A46 Newark Bypass

Scheme Number: TR010065

**Statement of Common Ground
with Nottinghamshire County Council**

Statement of Common Ground with Nottinghamshire County Council

Issue No.	Issue	Document Reference	Nottinghamshire County Council's Position	Applicant's Position	Status	Date status confirmed
		Figure 2.3 Environmental Masterplan [AS-026]

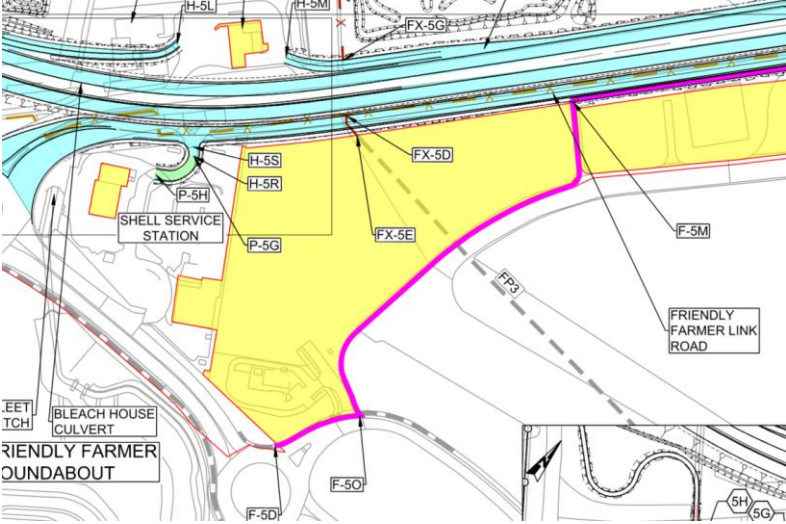
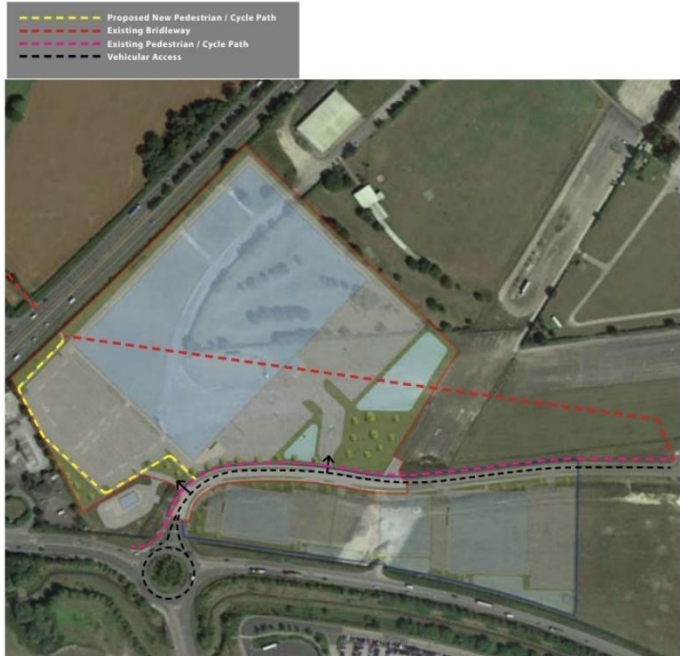
24.	Cultural Heritage - Winthorpe Conservation Area	Chapter 4 (Environmental Assessment Methodology) of the Environmental Statement [APP-048] Chapter 7 Landscape and Visual Effects of the Environmental Statement [APP-051]	<u>Impact on Winthorpe Conservation Area</u> NCC welcomes the revisions which have been made to the proposed route in response to previous consultation which will reduce the visual impact on the village of Winthorpe and reduce noise and vibration impacts on Winthorpe Conservation Area. However, the proposed flyover as part of Cattle Market junction will increase visual impact for residents on the northern edge of Newark. The smaller footprint of the Scheme should reduce the overall impacts on biodiversity and flood risk although these will still need to be addressed as set out in the accompanying detailed comments.	The design has been developed to meet the Scheme objectives and adheres to the principles of the design and mitigation hierarchy outlined in the standards for highways document of the Design Manual for Roads and Bridges LA 104 - Environmental assessment and monitoring. The first principle is to avoid potential adverse effects where possible, before seeking to finalise or mitigate any unavoidable impacts. At Cattle Market Junction, mitigation planting to reduce the impacts of the junction upon properties at Sandhills Park would be provided in order to soften the visual prominence of the structure and screen where possible. Details of the environmental design can be seen in Figure 2.3 Environmental Masterplan [AS-026] and further explained within Chapter 4 (Environmental Assessment Methodology) of the Environmental Statement [APP-048] and Chapter 7 (Landscape and Visual Effects) of the Environmental Statement [APP-051].	Under Discussion	18/10/2024

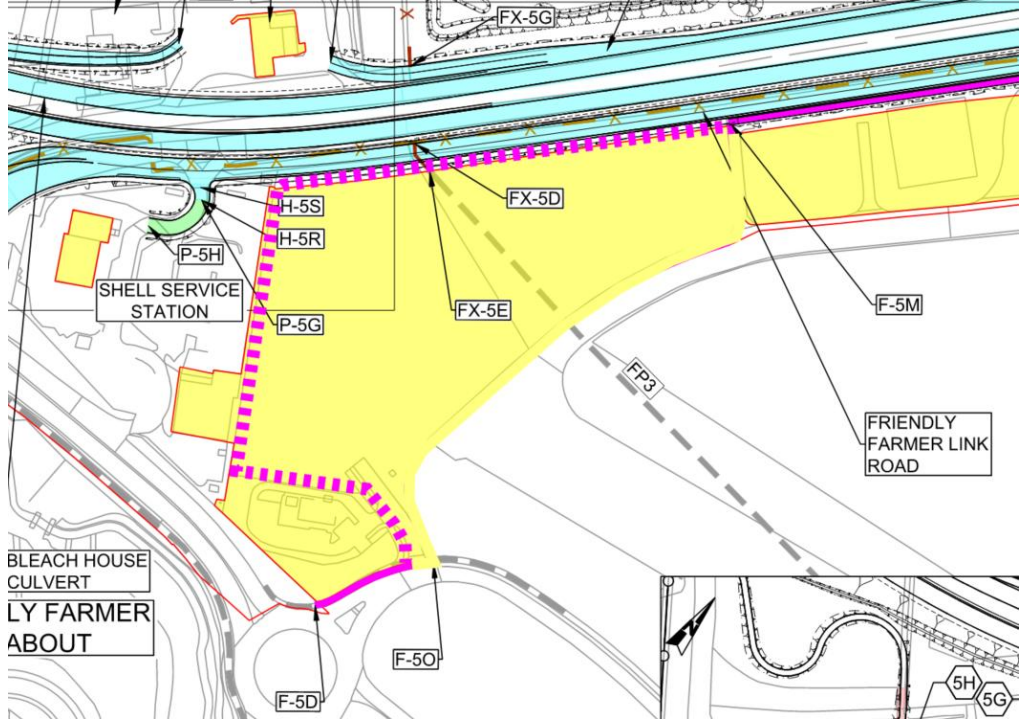
26.	Ecology	6.3 Environmental Statement - Appendix 8.6 Wintering Bird Technical Report [APP-151] 6.1 Environmental Statement - Chapter 8 Biodiversity [APP-052]	<u>Para. 9.5.11 Environmental Information report</u> It would be advisable for wintering bird surveys to be carried out during November and December this year, as well as March next year, to cover the whole winter period.	Wintering bird surveys were carried out across 4 visits in January to February 2022 and November to December 2022. This is in line with the core survey months for wintering birds (with reference to the Bird Survey Guidelines, birdsurveyguidelines.org and Bibby <i>et al.</i>, 2000, <i>Bird Census Techniques</i>). Transect routes were devised to survey a representative sample of the habitats within a 1km buffer of the Order Limits and were surveyed once per survey visit. Further details are available in 6.3 Environmental Statement - Appendix 8.6 Wintering Bird Technical Report [APP-151] and 6.1 Environmental Statement - Chapter 8 Biodiversity [APP-052].	Agreed	18/10/2024
